## TRANSPORT IMPACT ASSESSMENT

PROPOSED AGED CARE FACILITY

CORNER OF KARAKUL ROAD AND ANGORA ROAD, HAMILTON

(Response to EDQ Further Issues Letter, dated 21 August 2024)

**FIGURE 5.1 – PROPOSED VEHICLE CROSSOVER LAYOUT AND DIMENSIONS (KARAKUL ROAD)**

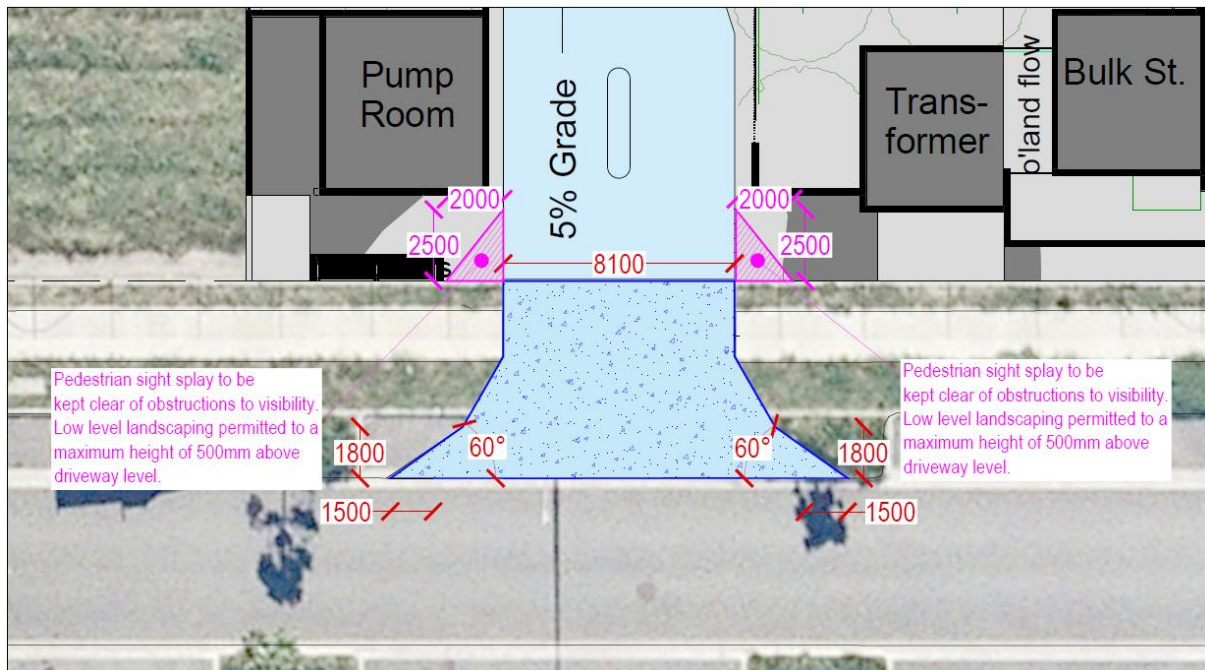
Section 5 of the Traffic Impact Assessment report contains errors, such as referencing an existing driveway that does not exist and it states a crossover width that is inconsistent with what is dimensioned on the referenced figure. Submit an amended Traffic Impact Assessment report to correct the abovementioned.

It is noted that the vegetated buildout shown on the western side of the driveway is not sufficiently sized to offset the loss on the eastern side. Submit amended engineering plans to demonstrate the vegetated buildout be extended to meet the driveway flare.

Section 5 has been amended.

Vehicular access will be located from a single crossover located at the northern end of the Karakul Road frontage. As shown in Figure 5.1, it is proposed that a Type B2 (8.1m) crossover be provided.

It is noted that the existing vegetated build out will be modified to suit the new vehicle crossover arrangements.

FIGURE 6.1 – SWEPT PATHS OF REAR LIFT REFUSE COLLECTION VEHICLE AT ACCESS DRIVEWAY

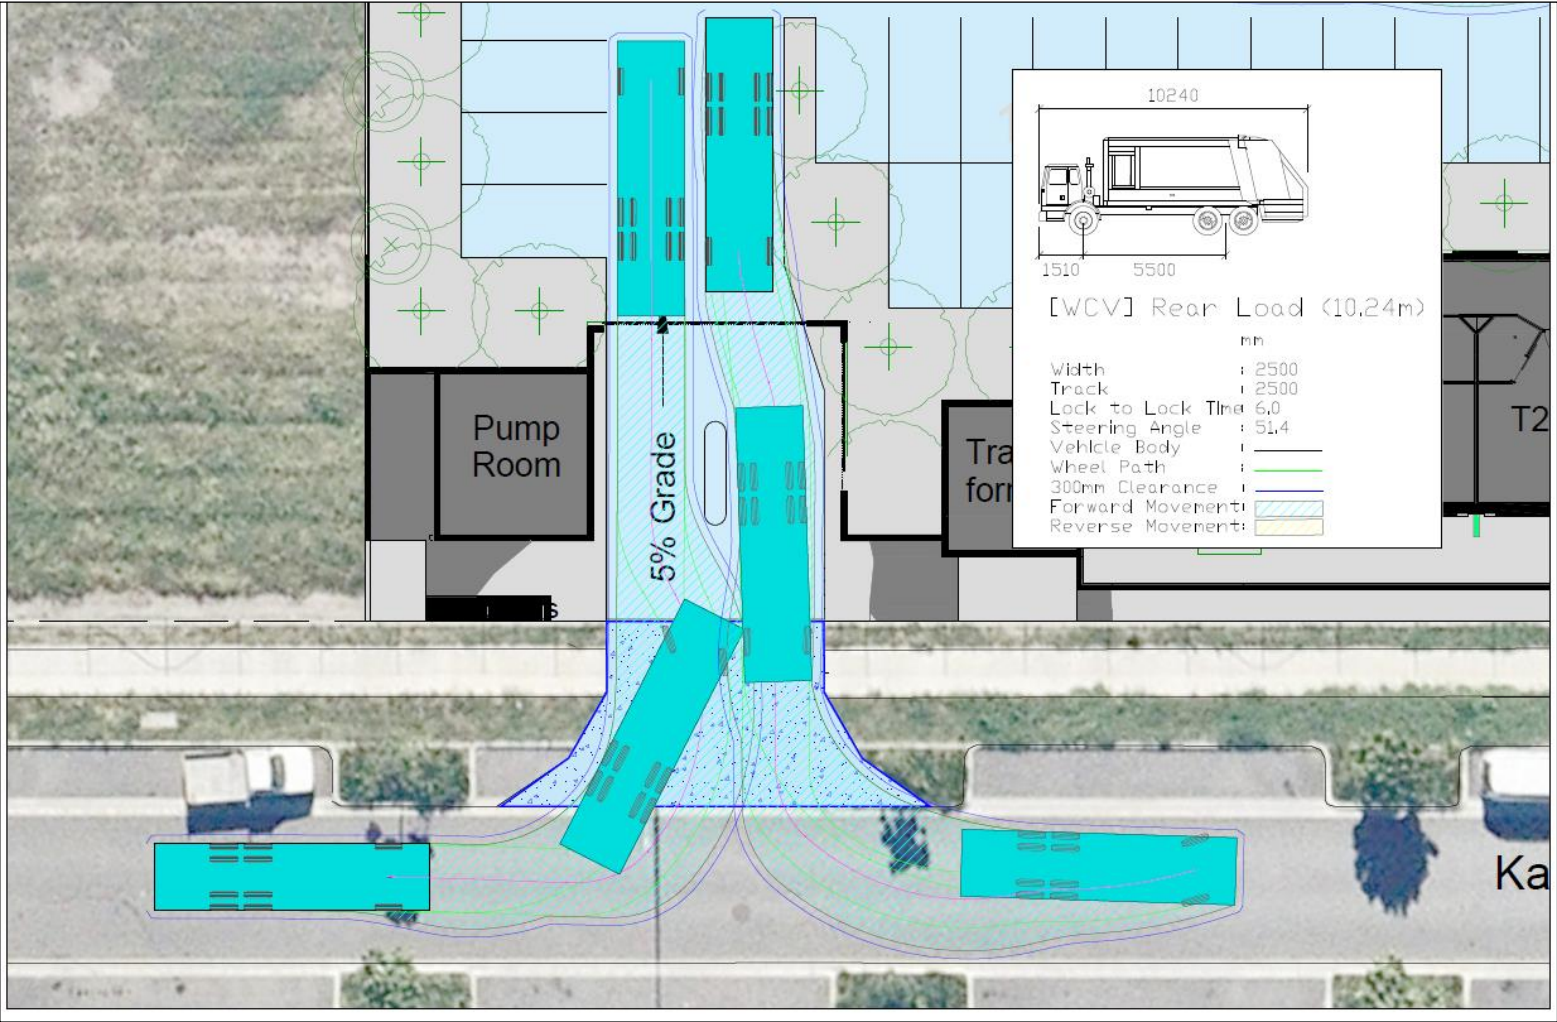
Furthermore, the swept path analysis references rear load RCV, however the report conclusion references a front loading RCV. It is noted the operating clearance for front loading RCV is significantly higher (as detailed in the Refuse PSP). Clarification and revised swept paths are required to demonstrate the proposed service vehicle and comply with the abovementioned requirements.

As shown in Figures 6.1 and 6.2, the proposed loading facility satisfactorily allows for access by rear lift Refuse Collection Vehicle. The largest delivery vehicles will be smaller than an RCV.

FIGURE 6.2 – ON-SITE MANOEUVRING FOR REAR LIFT REFUSE COLLECTION VEHICLE

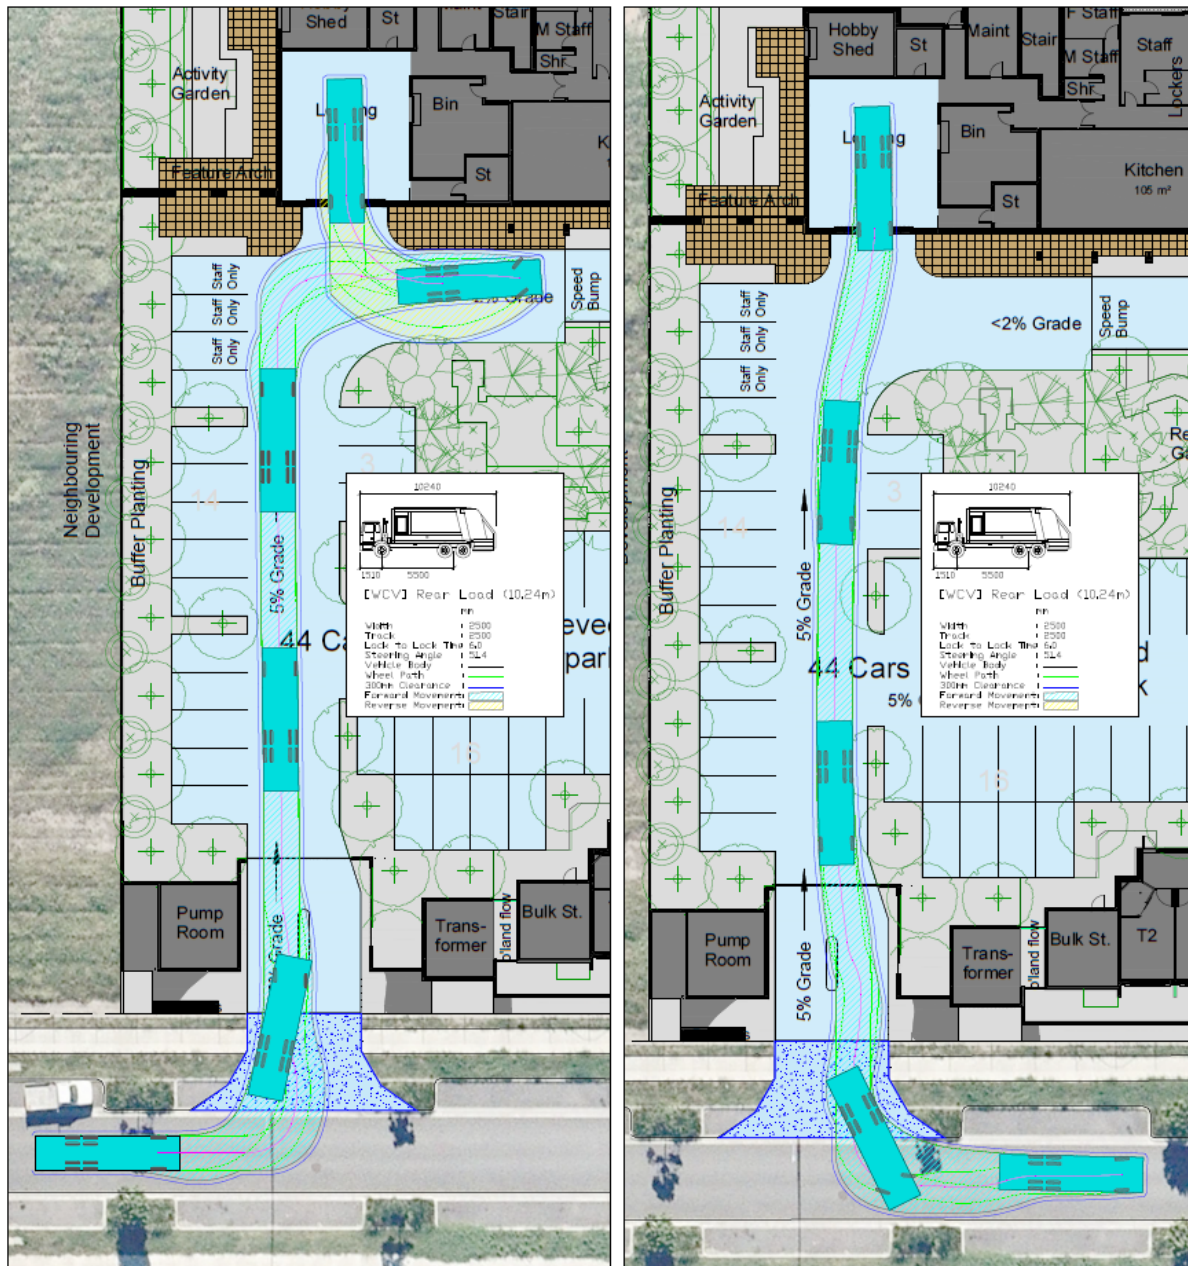
The occasional service vehicle for the proposed development, based on the Transport, Access, Parking and Servicing (TAPS) Planning Scheme Policy (PSP) of Brisbane City Plan 2014 (City Plan), is an LRV. As mentioned in the Traffic Impact Assessment report, the 10.24m LRV is significantly smaller than the standard 12.5m LRV. Submit amended swept path analysis certified by RPEQ to demonstrate manoeuvring for LRV (Please note that the swept path analysis and 10.24 m LRV is not supported by Council).

In addition, the submitted materials are not clear to demonstrate the site can be suitably serviced by the relevant design vehicle, with any Porte-cochere structure to exceed the clearance requirements for RCV circulation to operate as shown in the Traffic Impact Assessment report. To ensure sufficient on-site waste collection can be serviced, a minimum of 4.5 meters vertical height clearance over the loading dock and drop-off areas must be provided.

The site plan has been modified so that a Heavy Rigid Vehicle (HRV) can access and manoeuvre on-site. This sized vehicle will not require regular access and will need to manoeuvre over four staff allocated parking spaces. This is considered to be satisfactory as management can arrange for those spaces to be kept clear when such a vehicle is scheduled to arrive.

In accordance with Table 1 of the TAPS PSP, a Residential Care Facility is required to make provision for Regular access by a Large Rigid Vehicle. The site plan has been modified so that a Heavy Rigid Vehicle (HRV) can access and manoeuvre on-site (refer to Figure 6.3). This sized vehicle will not require regular access and will need to manoeuvre over two staff allocated parking spaces. This is considered to be satisfactory as management can arrange for those spaces to be kept clear when such a vehicle is scheduled to arrive.
